Landscape Referral Response

Application Number:	Mod2015/0247
Date:	09/03/2016
Responsible Officer:	
Land to be developed (Address):	Lot 100 DP 1015283 , 145 Old Pittwater Road BROOKVALE NSW 2100 Lot 2741 DP 752038 , 2741 / 9999 Condamine Street MANLY VALE NSW 2093 Lot 2 DP 600059 , 75 Old Pittwater Road BROOKVALE NSW 2100 Lot 2742 DP 752038 , 2742 / 9999 Condamine Street MANLY VALE NSW 2093 Lot 30 DP 204107 , 30 / 0 Old Pittwater Road BROOKVALE NSW 2100

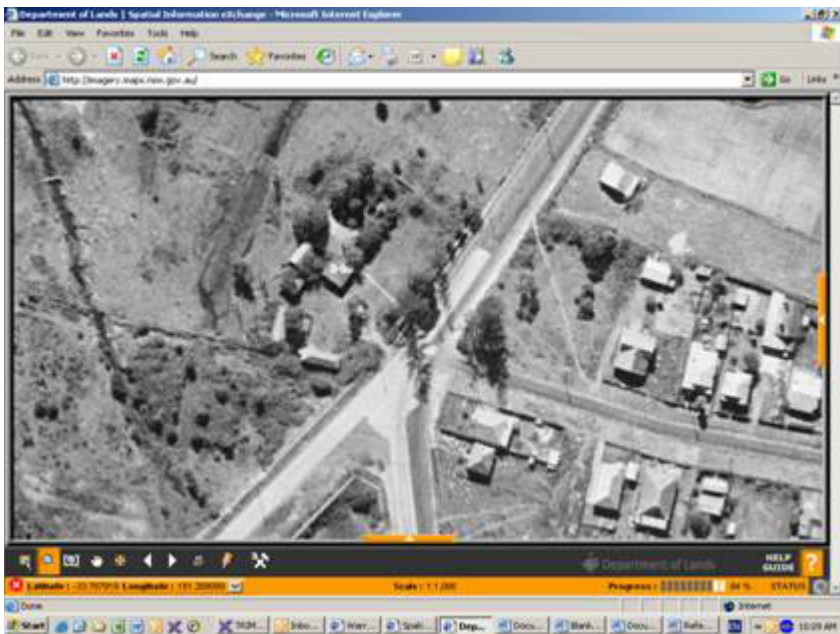
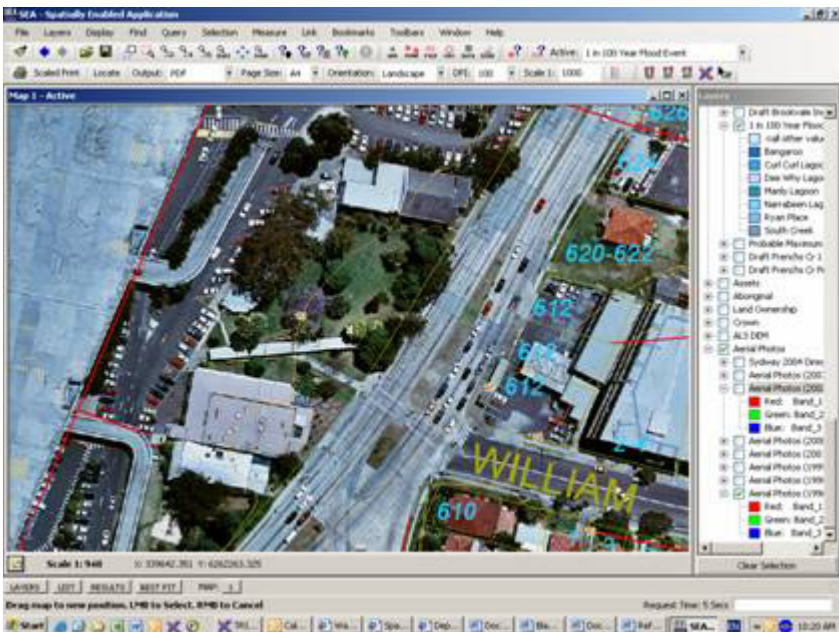
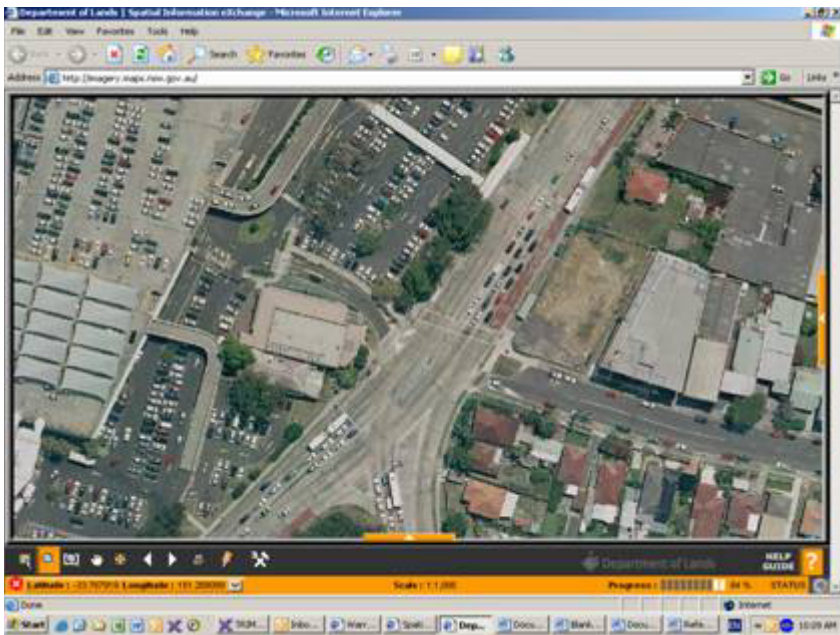
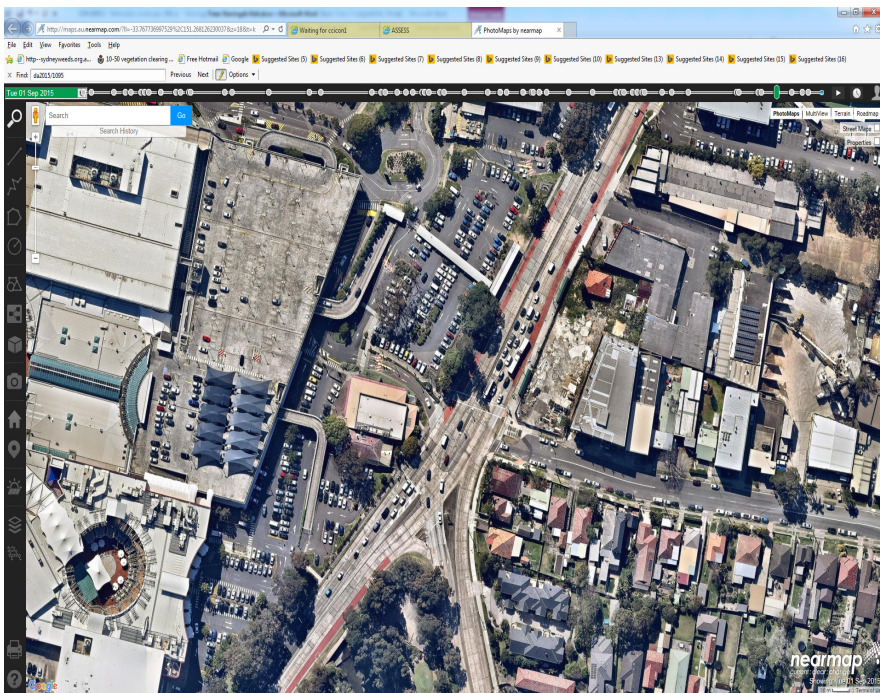
Review of air photos from 1943 indicate the presence of vegetation including Norfolk Island Pines in this location. Images from 1910 obtained through Council's Library Service indicate Norfolk Island Pines in a similar location forward of Brookvale House. The planting may therefore be remnants of the Brookvale House gardens.

As a long standing landscape element that appears to pre-date the Warringah Mall and has been retained during its existence, the trees are considered significant enough to warrant retention.

In the event that no alternative can be engineered, replacement planting should reflect the trees removed in this location.
